Permit Application Review Report
Date: 1/8/2025

Project Name: Entsminger Estates

Project PAN: P-24-040

Project Purpose: Mass grading, construction of stormwater management, house pad preparation and site restoration for 3 new single-family residences

Figure 3: Erosion and Sediment Control Plan

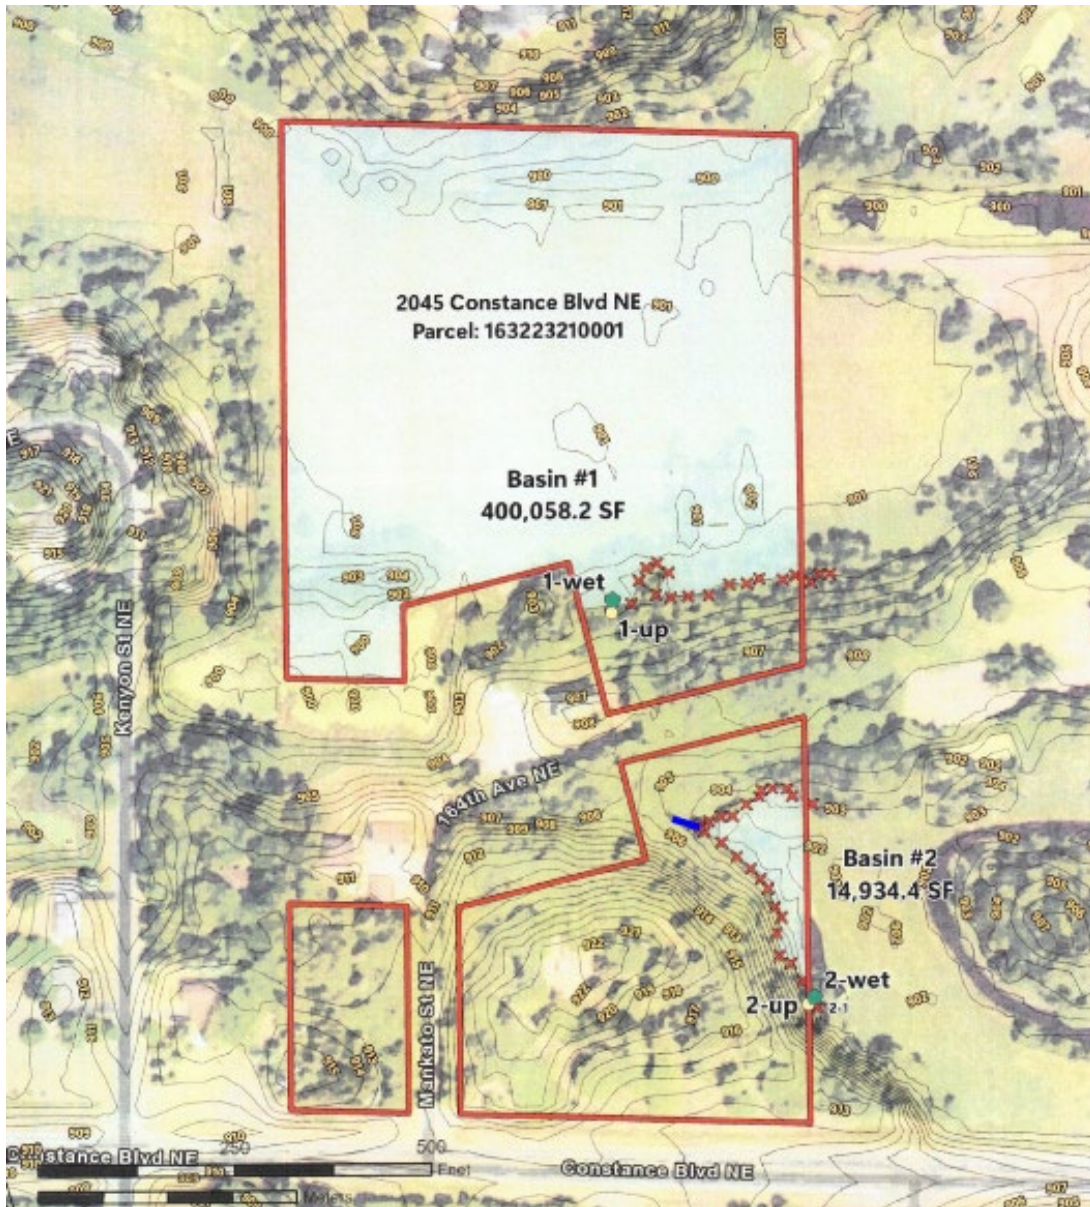
The proposed project drains to County Ditch 58. The soils affected by the project includes Zimmerman, Isanti, Lino and Markey which have a soil erodibility factor of 0.15 or greater. Disturbed areas are proposed to be stabilized within 24 hours, as required. The proposed erosion and sediment control plan includes perimeter control, street sweeping, and stabilized construction entrance. The erosion control plan meets District Requirements. The site does require a NPDES permit. See attached Figure 3: Erosion and Sediment Control Plan.
